Report: Deficiency Report
Function: Test, Adjust, & Balance
Date: 09/17/2025
Completed By: National TAB

PROJECT
09-15-25 CAVA NAPLES, FL

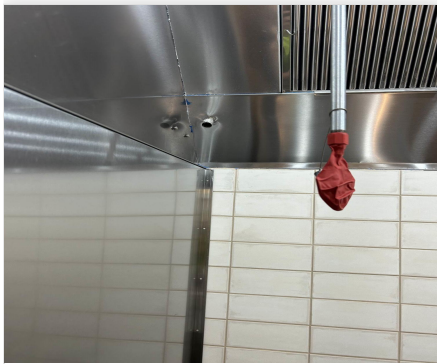
Issue Name : Kitchen Hood - Ceiling Enclosure
Description : There is a missing enclosure panel on the back corner of the kitchen hood, leaving a small gap that's open to the ceiling. Recommend installing.
Created By : National TAB **Assigned To :** National TAB - Mark Johnson
Status : Open
Priority : High **Asset Tag :**
Originated Date : 09/17/2025 - Mark Johnson - National TAB

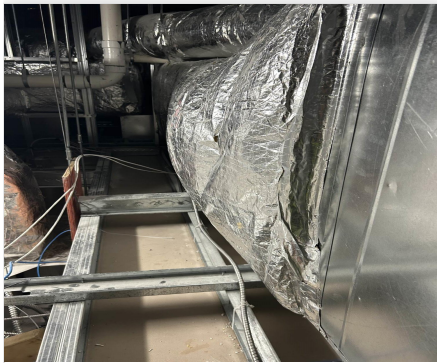
Issue Name : Kitchen Hood - Grease Cups
Description : Hood grease cups are not yet installed. Recommend installing.
Created By : National TAB **Assigned To :** National TAB - Will Turnbough
Status : Open
Priority : Medium **Asset Tag :**
Originated Date : 09/17/2025 - Mark Johnson - National TAB

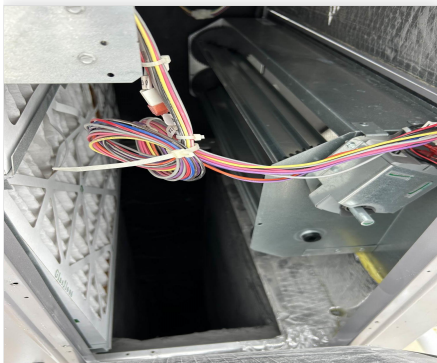
Issue Name : RTU 2 - Duct Leakage
Description : The section of RTU 1's trunk line near the main drop appears to be experiencing leakage; the surrounding insulation is puffing out, and airflow can be felt from gaps in insulation. Recommend mechanical inspection.
Created By : National TAB **Assigned To :** National TAB - Will Turnbough
Status : Open
Priority : Urgent **Asset Tag :**
Originated Date : 09/17/2025 - Mark Johnson - National TAB
